State of Colorado  
Oil and Gas Conservation Commission

## SUNDRY NOTICE

1. OGCC Operator Number: 96850 API Number: 05-045-20524-00
2. Name of Operator: WPX Energy Rocky Mountain, LLC OGCC Facility ID #
3. Well/Facility Name: Clough Well/Facility Number: NR 512-3
4. Location (QtrQtr, Sec, Twp, Rng, Meridian): NESW Section 3-T6S-R94W

**From:** Burt, Samuel [Samuel.Burt@wpxenergy.com]  
**Sent:** Friday, June 29, 2012 2:42 PM  
**To:** Andrews, David  
**Cc:** Tannehill, Julie; Hejl, Kent; Davis, Gregory  
**Subject:** RE: NR 512-3 update

- Wellbore diagram outlining TOC, damage, MVRD, TOG, and TD

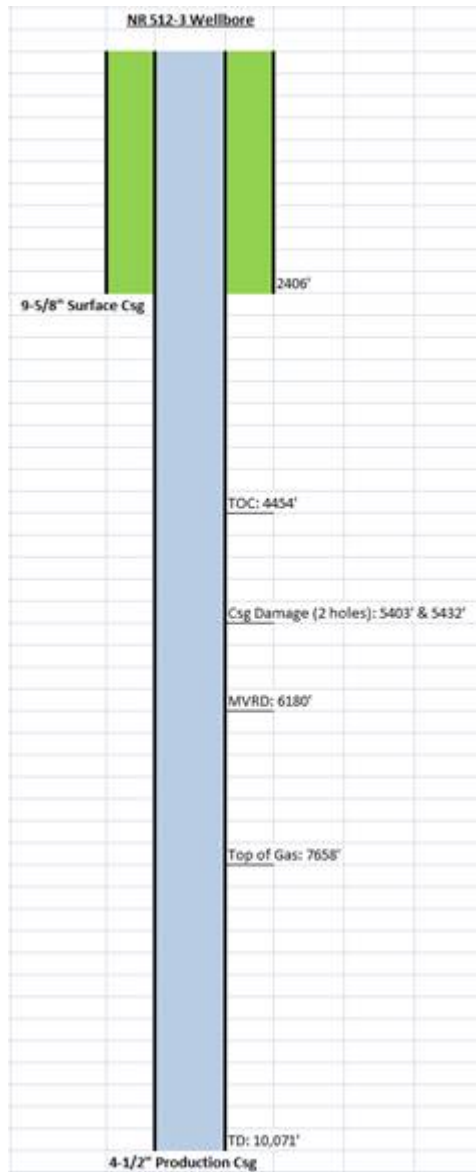
- MVRD: 6180'
- Top of Cement: 4454'
- The CBL can be found at the following site:

**COGCC Comments:** Casing holes have been reported at 5403' and 5432' (in the Wasatch Formation). Gas is migrating up channeled cement from the upper portion of the Williams Fork Formation and through the casing holes into the production casing. There is no Williams Fork or other Mesa Verde Group completed interval, and bradenhead pressure has been zero. **COGCC Conditions of Approval:** 1) Production of Williams Fork gas through the Wasatch casing holes is approved for a period not to exceed 12 months. 2) Before the end of the 12-month period, a remediation plan must be submitted on a Sundry Notice, describing planned remediation of the casing holes, all planned cement squeeze(s) above the Williams Fork top of gas, and proposed Williams Fork completion intervals. A post-remediation CBL will be required. 3) During this 12-month approval period, bradenhead pressure shall be monitored and recorded at least weekly, and monthly bradenhead monitoring reports shall be emailed to [david.andrews@state.co.us](mailto:david.andrews@state.co.us) no later than the 10<sup>th</sup> of the month for the previous month's summary.

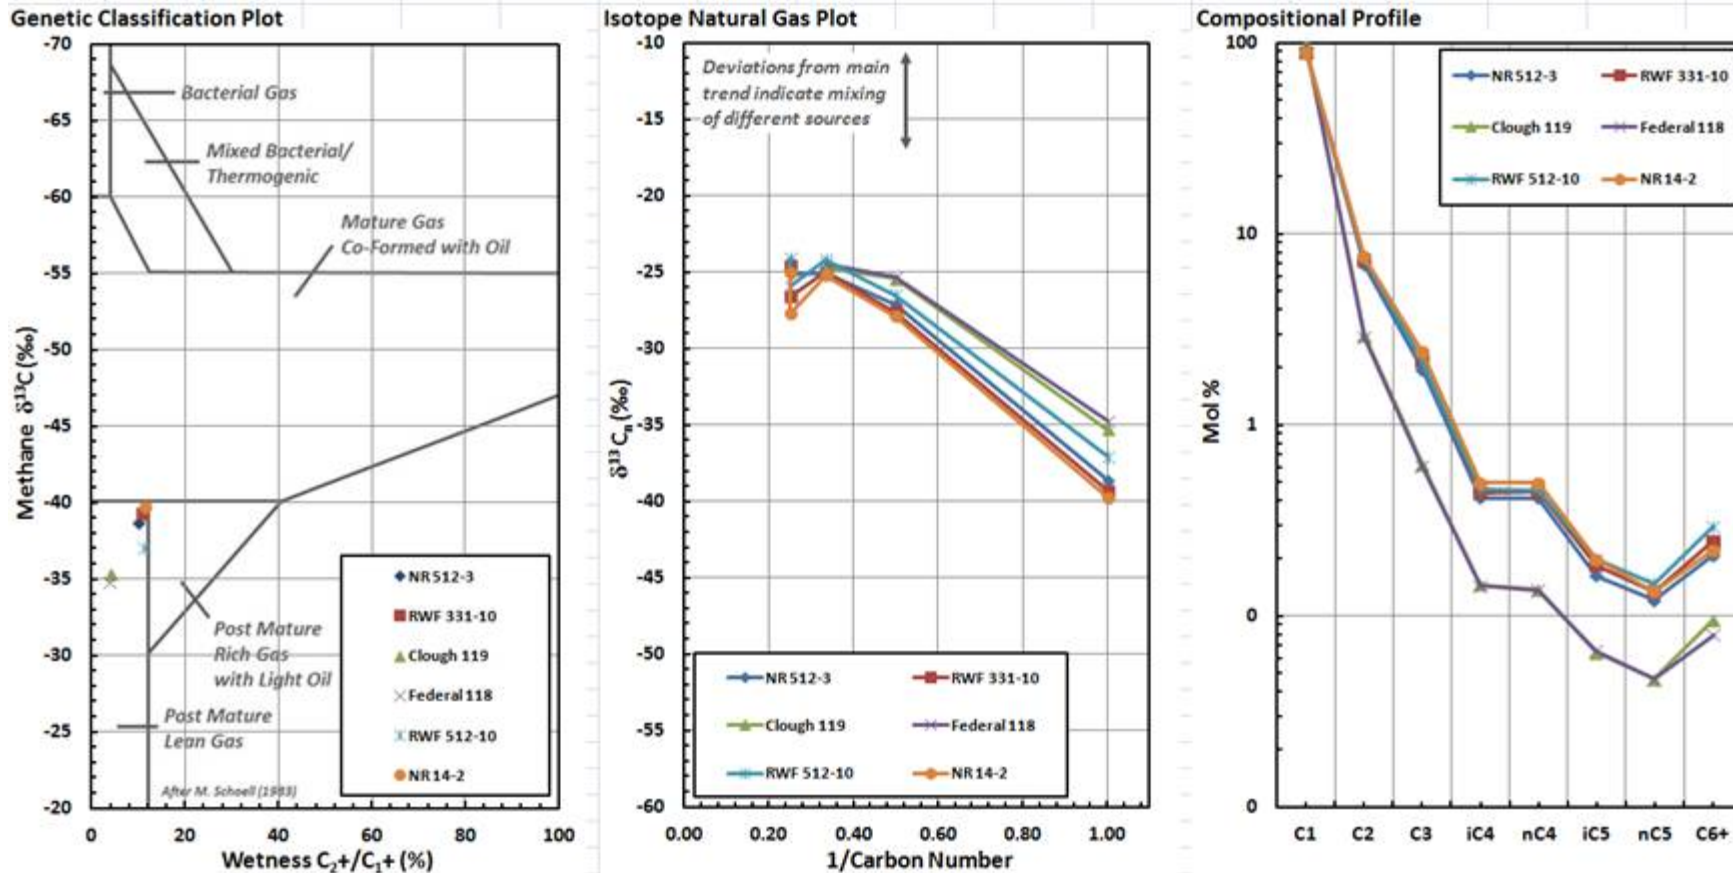
Secondly, WPX is permitted to produce gas from the Williams Fork formation. Gas samples were taken from the NR 512-3, as well as from the closest bottom-hole Wasatch (Clough 119 & Federal 118) and Williams Fork (RWF 331-10, NR 14-2, & RWF 512-10) wells, for comparison purposes. Samples were tested for composition, isotopes, and wetness. Conclusive results indicate that the gas being produced from the NR 512-3 is from the Upper Williams Fork. Please refer to the graphs below for gas analysis results:
